REMARKS

Rejection under 35 U.S.C. §112, second paragraph

FIG. 4

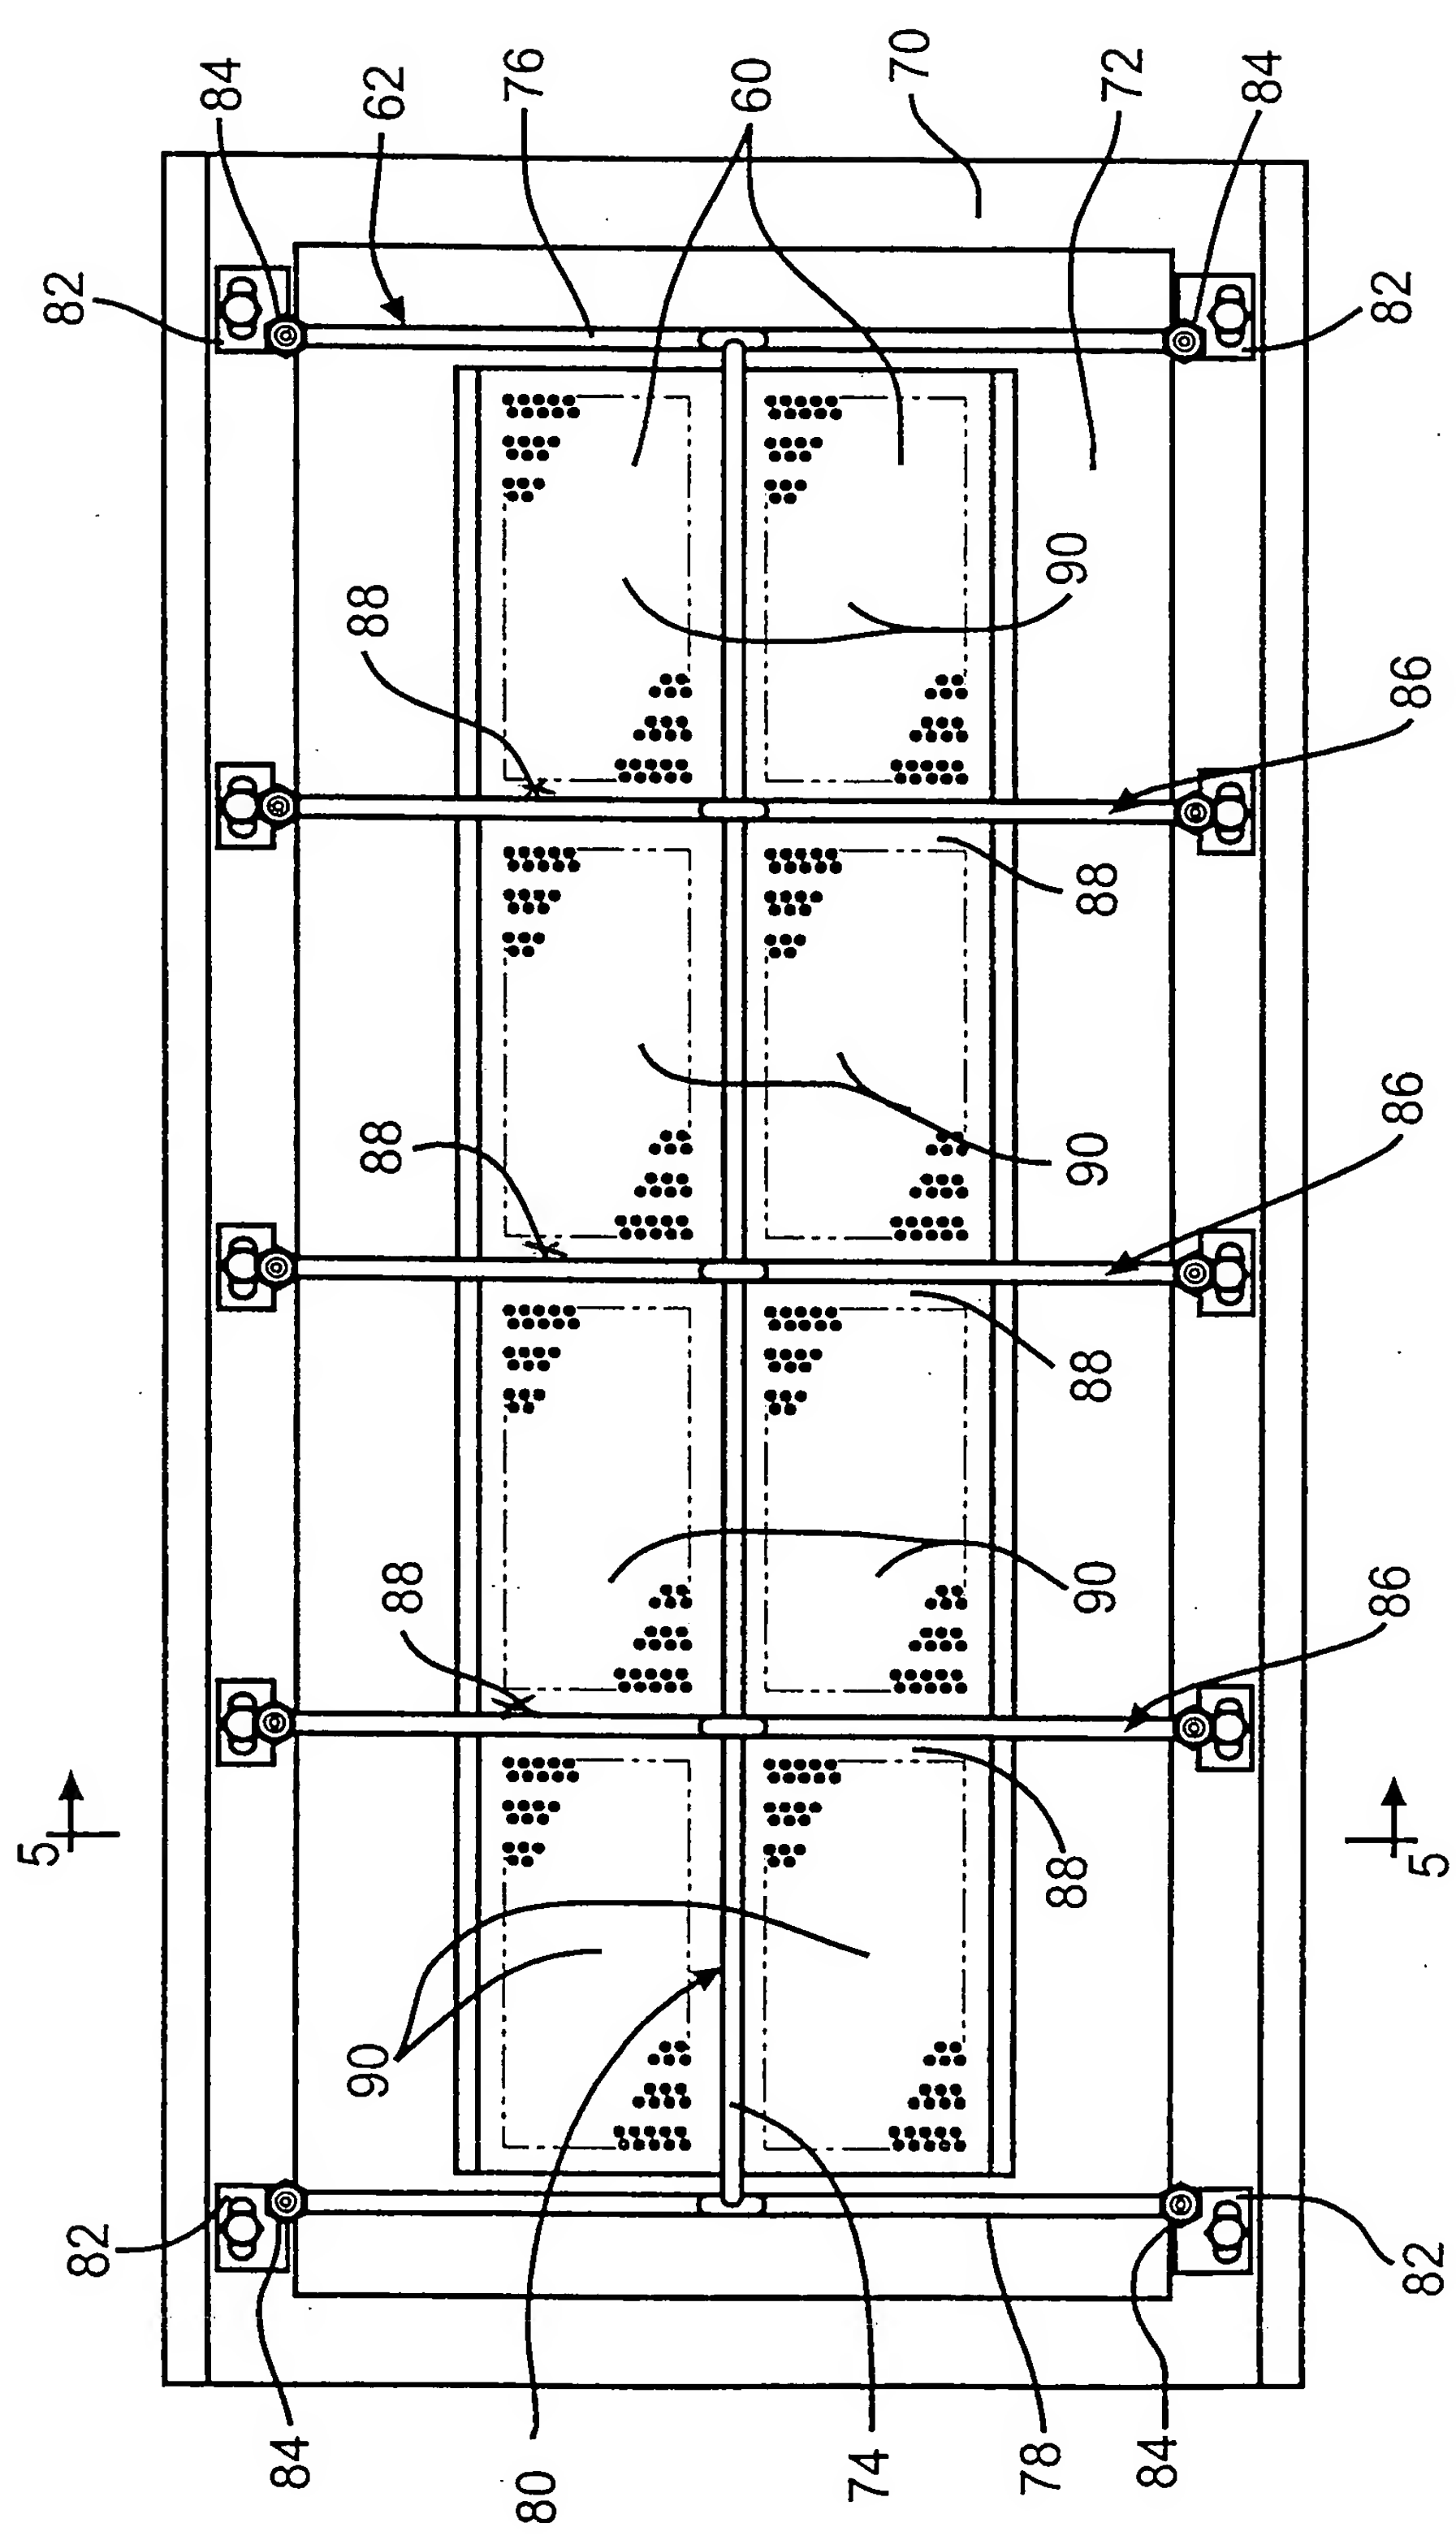
The term “section spacing” is defined at page 7, paragraph 3 of the specification, “...the tip plate 60 is provided with a plurality of tip sections 90, each separated by dead space, or section spacing 88. A plurality of tips 16 (best shown in Fig. 1) occupies each tip section 90. No tips 16 occupy the section spacing 88.” Further, Fig. 3 indicates “section spacing 88” as the space between the lateral support 86 and the tip sections 90. Further, in Fig. 4, the “section spacing” is shown, in three occurrences, as 88 as the space between the lateral support 86 and the tip sections 90. In Fig. 4, there are three other erroneous occurrences of 88 pointing to the lateral support 86. This is merely a draftsperson’s error.

Applicants have amended the three errors in Fig. 4 herein. No new matter has been added and support for the amendments can be found in the specification, as described above and in Figs. 3 and 4. A marked-up copy of the drawing and a substitute drawing is enclosed herein.
